Comments on the Non-handheld Equipment Inventories in ARB's Small Engine Initial Statement Of Reasons (ISOR)

Air Improvement Resource, Inc.

November 18, 2021

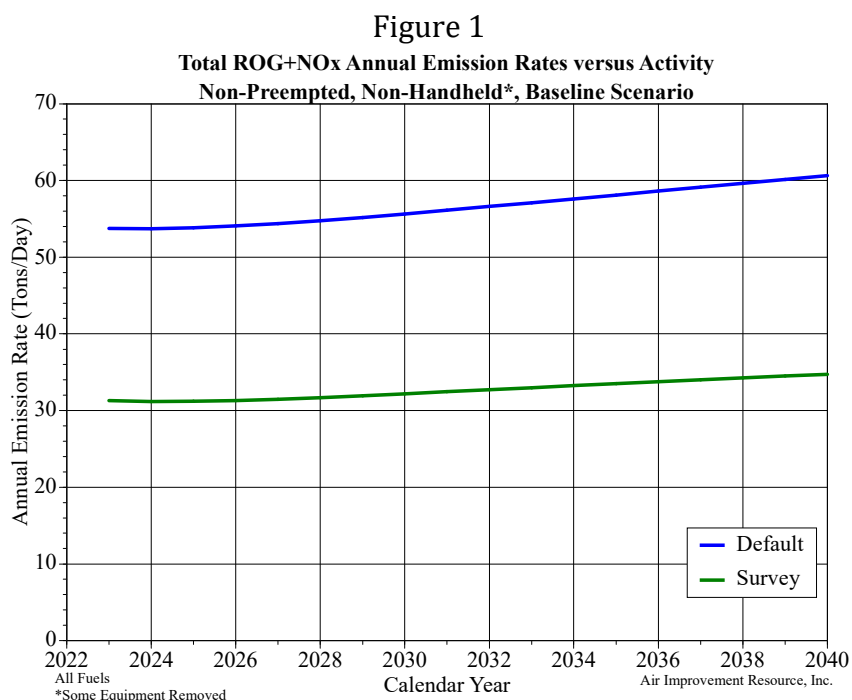
Figure 1 shows much lower small engine inventories for the more realistic activities calculated by AIR which was the main goal of the CSUF survey was to calculate a more accurate inventory of SORE emissions and modeling - than for the default ARB inventories.

Figure 2

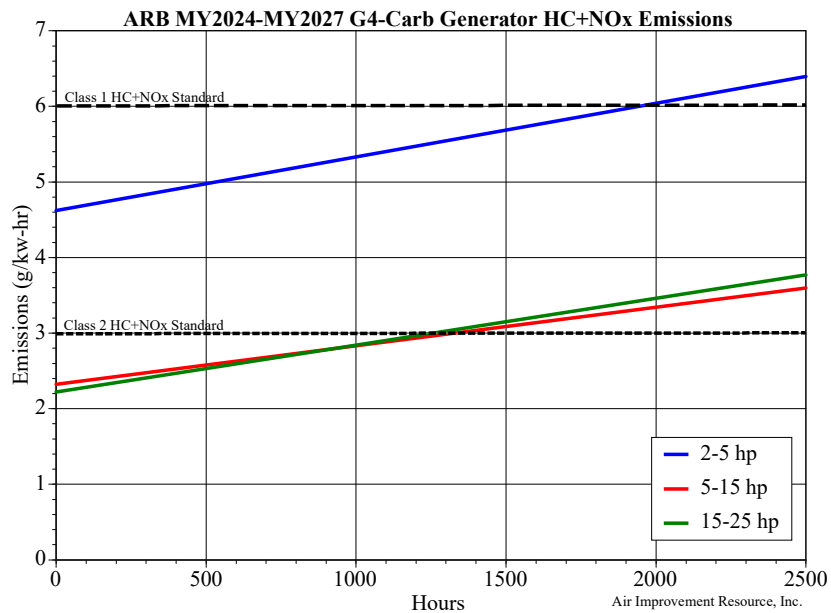
AIR reviewed the in-use emissions in the SORE2020 model and found the exhaust emissions for current standard engines to be overly pessimistic. AIR also reviewed the in-use exhaust emissions for generators certified to the 6 and 3 g/kw-hr Class 1 and Class 2 emission standards proposed for model years 2024-2027 and found these in-use emissions projections by ARB for these standards to be reasonable. The in-use ROG+NOx emissions for these standards are shown in Figure 2. Since under either the ARB or EMA proposals emission standards would change to lower levels and durability periods would be lengthened, this analysis will spend no effort to critique ARB's in-use exhaust emissions for the current Class 1 and Class 2 emission standards.

Figure 3

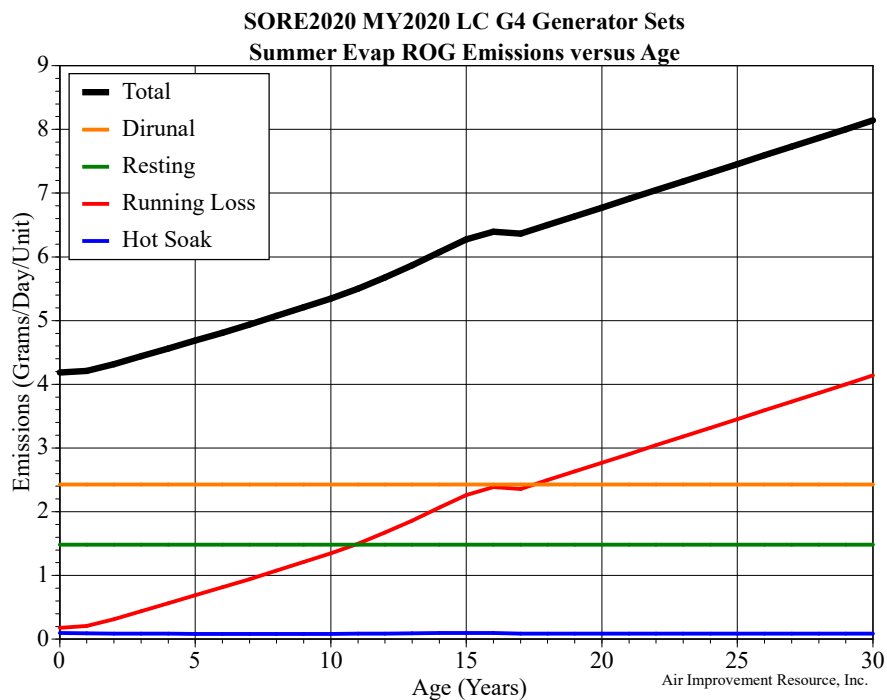
Figure 3 for generators shows a large increase in running loss emissions versus age, and the increase in running loss emissions drives total evaporative emissions higher. The other components are flat with age. Figure 4 for lawnmowers shows a large

increase in diurnal and resting loss emissions for lawnmowers, which drives total emissions higher with age.

Generator Running Losses – ARB’s generator running loss emissions are developed in an ARB report, and the data used come from a study by ATL.^{8,9} The testing was conducted in 2002-2003, and only 2 generator engines were tested. One of these engines is over twenty-five years old, and the other is over twenty. The two engines and their tests are show in Table 2.

The two running loss results are quite different. Because the higher result was a somewhat older machine, ARB assumed running loss emissions were small when the equipment is new, and high when the equipment is old. However, there are only two tests, which does not provide a robust sample size, and ARB has not tested any additional generators for running loss emissions in the last twenty years.

Generators meeting ARB Tier 3 evaporative standards have evaporative system charcoal canisters and purge systems for the canister. These systems are designed to store gasoline vapor during ambient temperature increases so that the vapor can be burned in the engine once it is started. These systems would control running losses as well. When the engine is started, if the tank temperature increases due to the engine, gasoline vapor would travel to the canister, and then continuously be purged as long as the engine is running. Thus, it is not appropriate to use the 1995 engine to represent running loss emissions for later model year generators that meet ARB MY2006+ emission standards.

We believe that it would be better to represent MY2006+ and later gasoline engines with the MY2002 Coleman, at 1.8 g/hr. The actual results could be even lower than this. Clearly, the MY1995 engine should not be used to represent generators meeting Tier 3 emission standards.

Figure 5

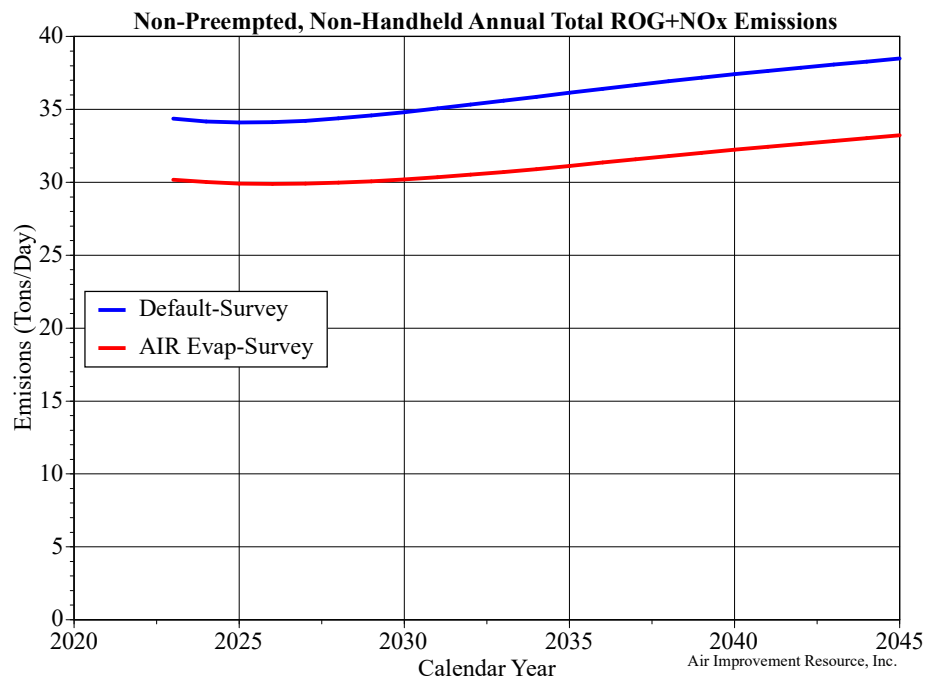
The impact of revising these evaporative emissions for generators and lawnmowers on ROG+NOx emissions baseline emissions is shown for both the ARB Survey and AIR Survey cases in Figure 5. Updating these evaporative emissions reduces the ROG+NOx inventory from non-preempted, non-handheld equipment by about 5 tpd.

Figure 6

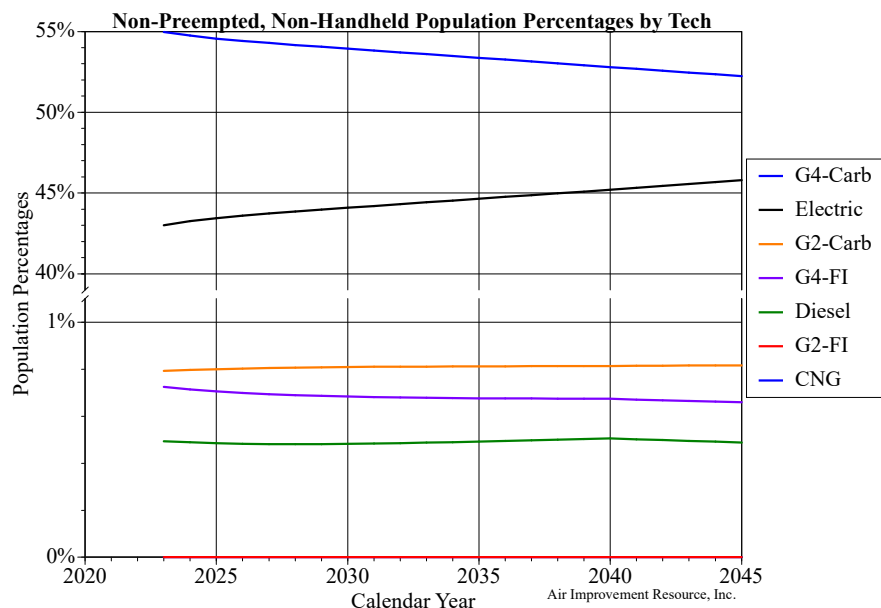
Figure 6 shows the penetration of electric equipment predicted by the SORE2020 model for non-handheld, non-preempted equipment for the 2023 to 2045 calendar years. The figure shows that the current electric percentage is about 43%, with growth over the next 22 years of only about 3%. This seems to be a very conservative projection for the baseline. The lower this projection is, the more benefit ARB can claim for its SORE regulation. There is little justification for this low of an electric fraction increase for the baseline in the SRIA or the ISOR based on the information provided in the Staff Report and SRIA, industry data provided by OPEI and publicly available data.

Electric equipment can be either corded or battery-powered. CARB staff do not expect much growth in corded electric equipment. However, for battery powered equipment and projected battery costs in the baseline, CARB staff cite a 2019 study by Bloomberg that indicates that battery costs will drop from \$131 per kw-hr in 2021 to \$70 per kw-hr in 2030.¹¹ CARB also indicates that some ZEE equipment would have lower cost than SORE equipment. If these projections are true, it should result in further battery-powered electrification of non-handheld equipment types under the baseline scenario.

Figure 7

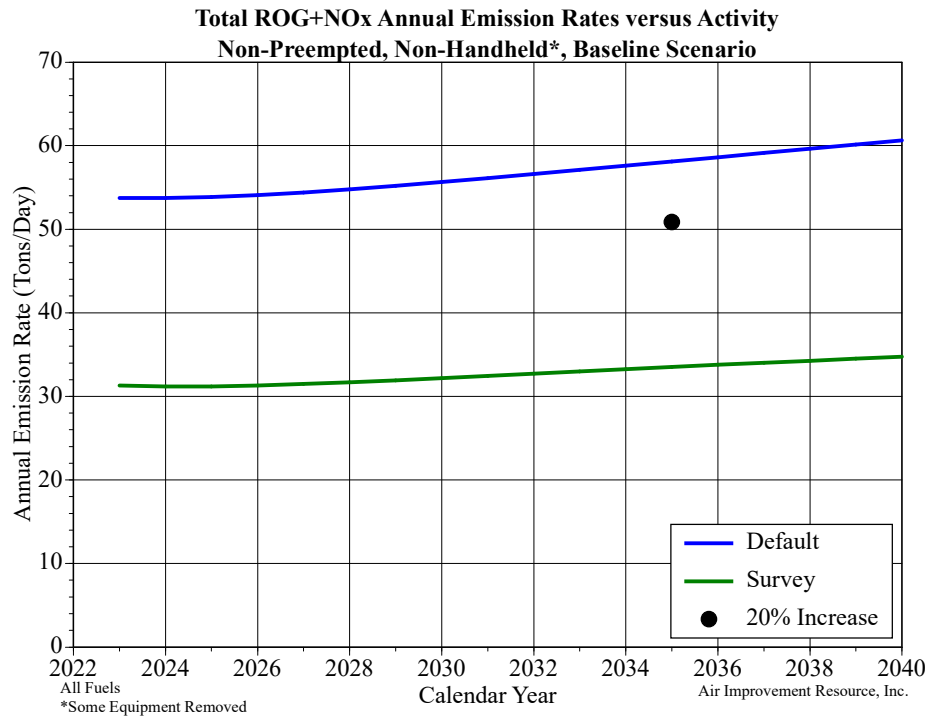
AIR evaluated a sensitivity case where we assumed that the electrification of non-handheld equipment would grow to be 20% higher than CARB staff estimates in 2035 in the baseline case. In this modeling, we used CARB's default activity estimates. Results are shown in Figure 7. The baseline inventory for 2035 drops from about 58 tpd to 51 tpd.

Figure 8

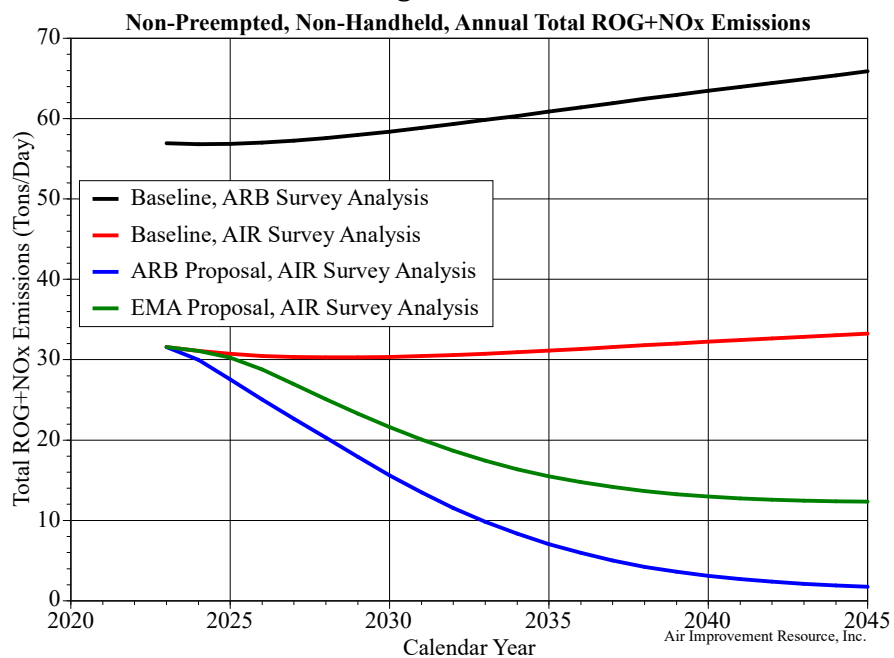
The ROG+NOx emission inventories of the EMA proposal in comparison to the ARB proposal are shown in Figure 8. This analysis uses the AIR annual use estimates discussed in Section 2. The EMA Tier IV proposal reduces ROG+NOx emissions from non-preempted, non-handheld equipment to approximately 11 tpd in 2045.

Figure 9

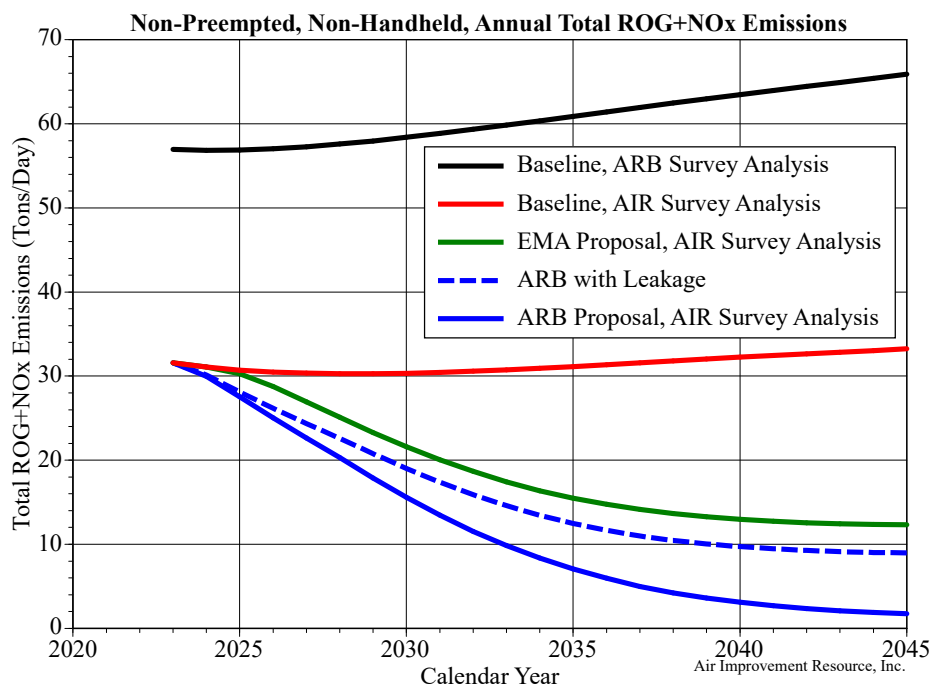
Figure 9 shows the impact of 50% landscape leakage and 10% residential/business leakage on the benefits of the ARB proposal. Purchases of equipment outside the state by landscaper, residential, and business users have a significant impact on the benefits of ARB's proposal. In addition, while not specifically modeled, slower fleet turnover would also significantly reduce the benefits of the ARB proposal.
